October 25, 2011

RE: CUYAHOGA COUNTY
CITY OF CLEVELAND
I-90 INNERBELT PROJECT
CONSTRUCTION STORM WATER

NOTICE OF VIOLATION

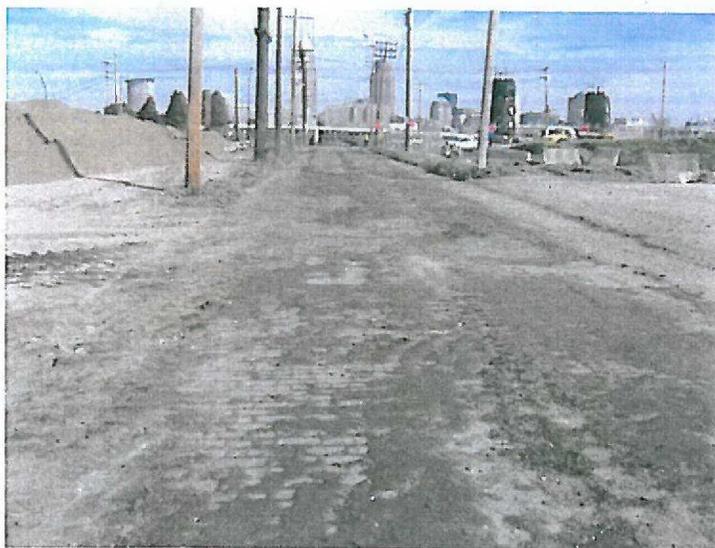
Fig 12 (LEFT). Stockpiles of erodible materials have been placed at the edge of the slope above the Norfolk Southern Railroad tracks. Either the stockpile can be pulled away from the edge so that silt fence can be installed, the pile can be stabilized with seed and mulch or it must be covered with a tarp to prevent off-site migration of sediment.

Fig 13 (RIGHT). I-52 has been installed, but requires maintenance. Accumulated sediments must be removed and the curb filter must rest against the curb.

Fig 14 (LEFT). Sediments are tracked out onto W. 15th St. More frequent street sweeping is recommended.

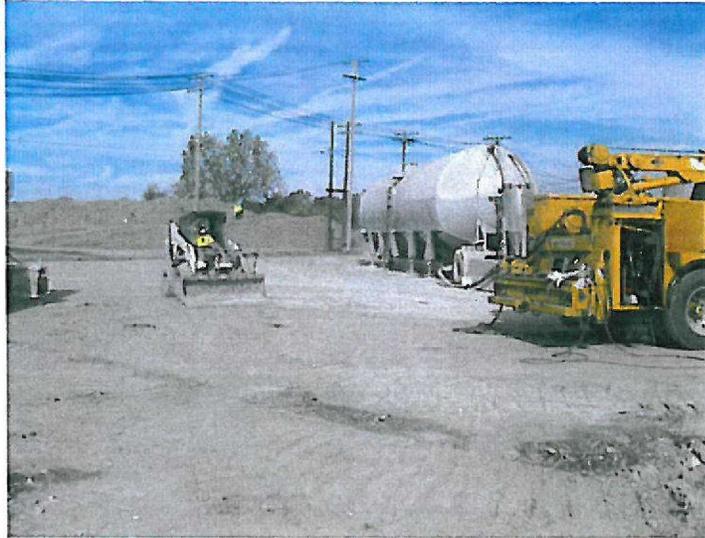
Fig 15 (RIGHT). I-53 has been installed, but a hole has been poked through the geotextile. This Dandy Bag must be replaced.

Fig 34 (RIGHT). Storm drain inlet protection along Commercial Rd requires maintenance. Note that the curb filter does not rest against the curb allowing sediment to enter the storm drain.

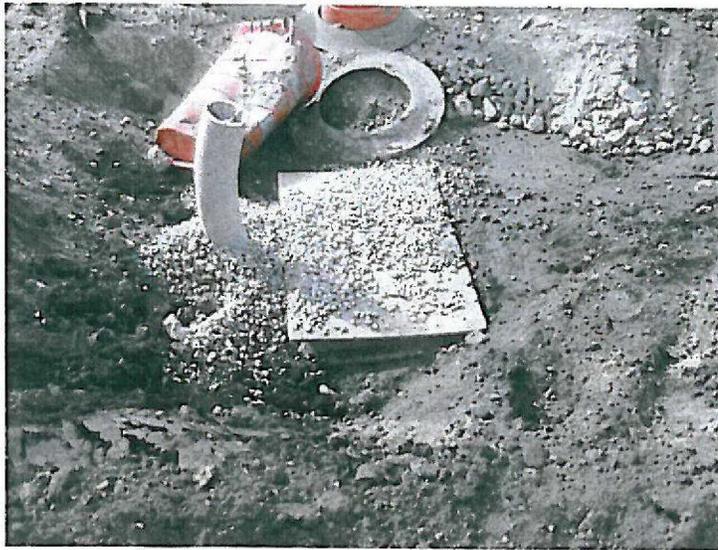
Fig 33 (LEFT). Soil has been placed on top of silt fence along Commercial Road. This compromises the function of silt fence.

Fig 36 (RIGHT). Silt fence must be installed around the back side of the soil stockpiles between Commercial Rd and the Norfolk Southern Railroad tracks. This area slopes down toward the railroad and then to the Cuyahoga River.

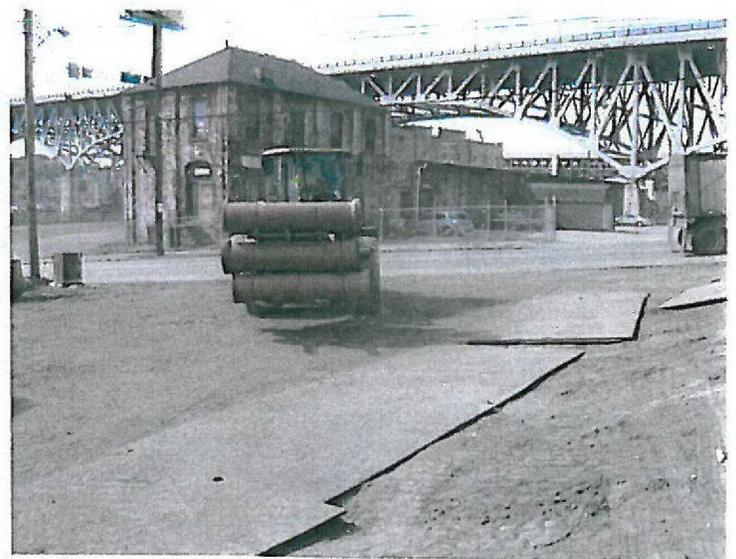
Fig 35 (LEFT). The storm sewer system for E. 9th St. Extension is currently being installed, however measures to keep sediment out of the sewer system is adequate. Here, a plywood board has been placed over a manhole.
